## **REMARKS**

***Amendments to the Drawings:***

Annotated Sheet Showing Changes

FIG. 2

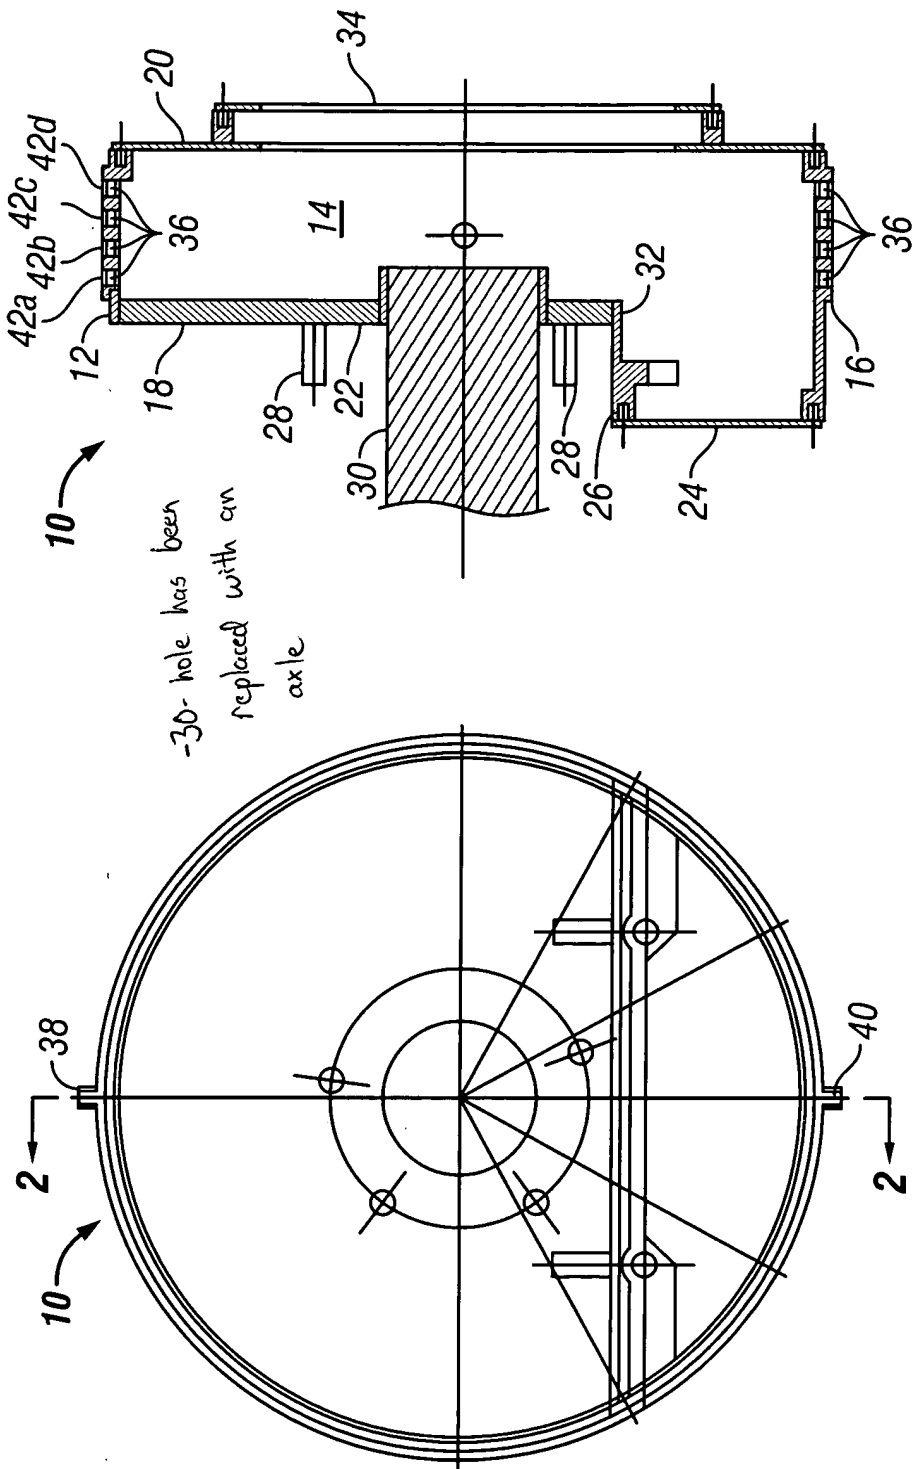
The drawings have been amended to comply with the Examiner's objections. Figure 2 has been amended to show the axle recited in claim 4. The objection concerning element 49 of figure 5 has been addressed by submitted an amended drawing with a correct numeral 52 as described in the specification. The objection concerning element 44 has been addressed by amending the specification to refer to elements 44a and 44b rather than an element 44. The objection concerning element 52 not being shown in the drawing has been addressed by correctly renumbering element 49 of figure 5 as element 52. The objection concerning element 64 not being shown has been addressed by adding a numeral 64 in figure 6 identifying a sealing means previously shown in the drawings. The amended drawings are believed to be in compliance with 37 CFR §1.121(d).

The attached sheet of drawings includes changes to Figures 2, 5, and 6. In Figure 2, previously omitted axle (identified as -30-) is added. Due to the change in the drawing, the “hole”, previously identified as -30- is no longer shown. The specification has been duly updated to reflect the change. The addition is supported in the previously filed specification. In Figure 5, -49- is changed to -52-. In Figure 6, element -64- has been identified.

FIG. 5

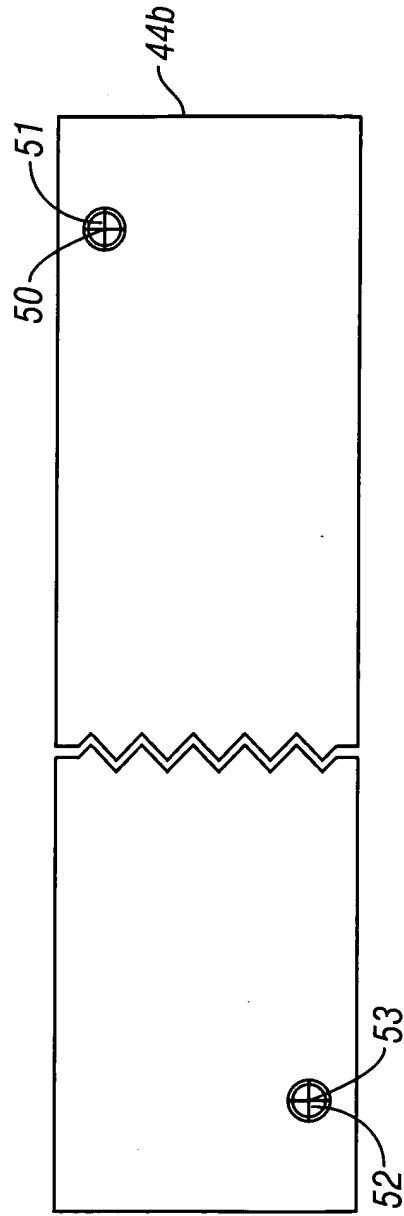
changed from -49- to -52-
